Mr. Lowell Braxton, Director
Division of Oil, Gas and Mining
1594 West North Temple, Suite 1210
Box 145801
Salt Lake City, Utah 84114-5801*Incoming
C/015/0015*Re: Emery Deep Mine Permit C/015/015
Amendment to MRP to revise partial pillar splitting plan (additional information)

Title: Updated Pillar Split Plan

Update the MRP to match the MSHA approved Pillar Splitting Plan (Additional Information)

**PILLAR SPLIT PLAN SITE SPECIFIC FOR
1ST AND 2ND SOUTH**

**Figure 1: Partial Extraction with Timbers for Supplemental Support
Mirror image applies**

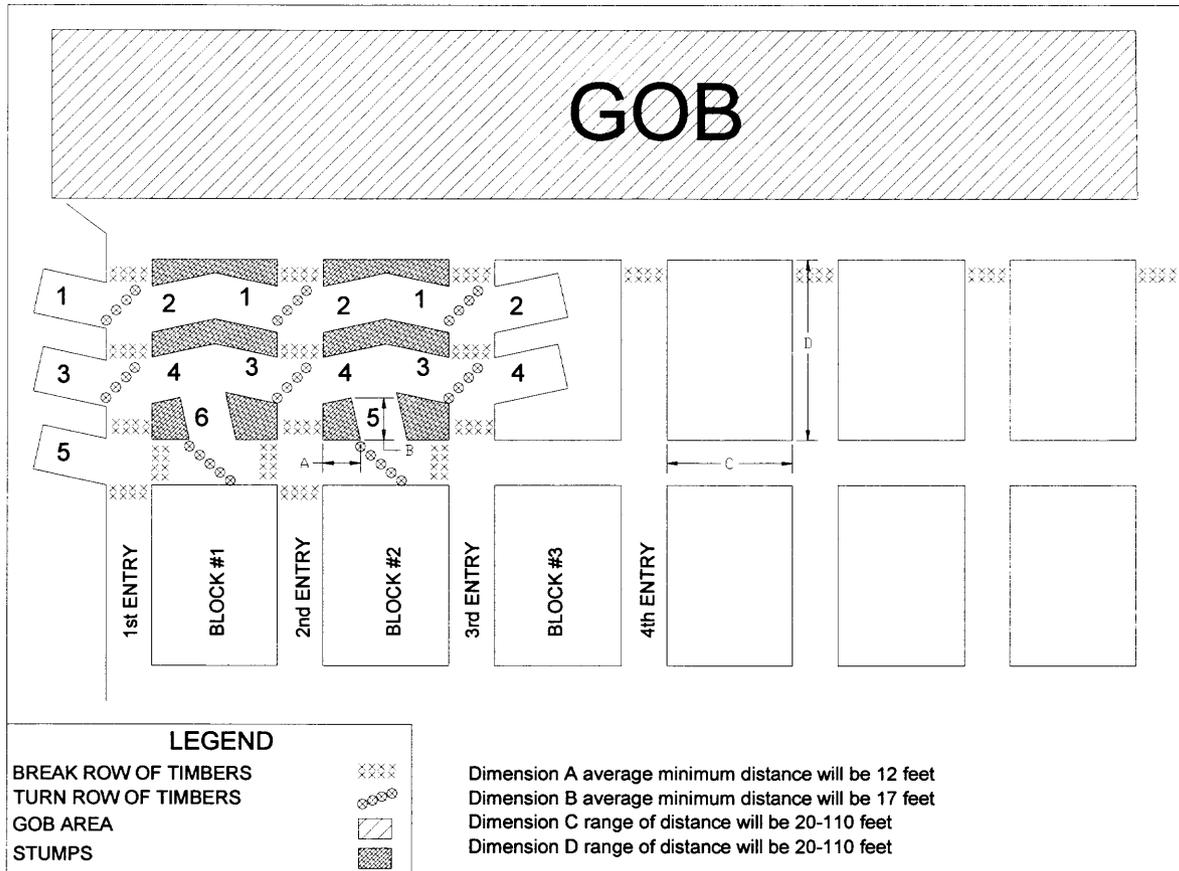
Please consider this additional information to supplement and replace some of the data submitted on December 10, 2004. Consol is submitting a revised partial pillar splitting plan, for the 1st and 2nd south sections.

1. A breaker row may consist of either:
 - a) two MRS units, or
 - b) two row of posts on a maximum spacing of four feet (4'), or
 - c) two cribs
